### <u>FINAL</u> <u>YEAR 5 (2018) MONITORING REPORT</u> UT TO MARTIN'S CREEK (CONTRERAS) MITIGATION PROJECT

Cherokee County, North Carolina
DMS Project No. 92766 (Contract No. 005717)
USACE Action ID No. 2010-00961/DWR Project No. 2010-00448
SCO No. 08-07249-01

RE: UT to Martin's Creek (Contreras) Monitoring (DMS Project # 92633, Contract # 005717) Final MY5 (2018) Annual Monitoring Report

Site	UT to Martins (Contreras)
Project Number:	92766
XS ID	XS - 7, Riffle
Reach	UT 1
Date:	4/1/2018
Field Crew:	Perkinson, Butler

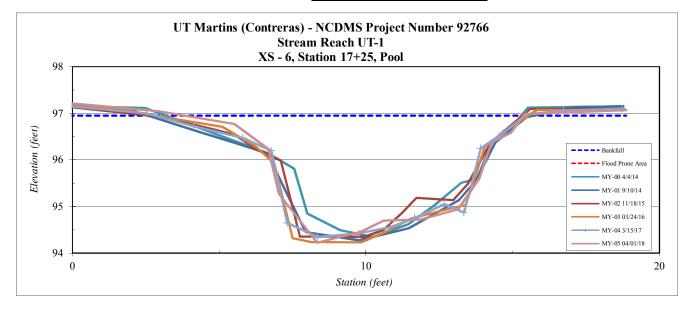
The data for cross sections 7 and 8 were revised to assure that the bankfull area remained fixed from last year's data. The graph and table were updated to reflect this change.
- As Axiom has done in the past, please include a response to the comment letter and how/where the comments were
  addressed. Please insert this letter directly behind the cover page in the final deliverables.
   This comment letter has been included just behind the cover page in the final deliverable. A word document is also
  included in the digital submittal.
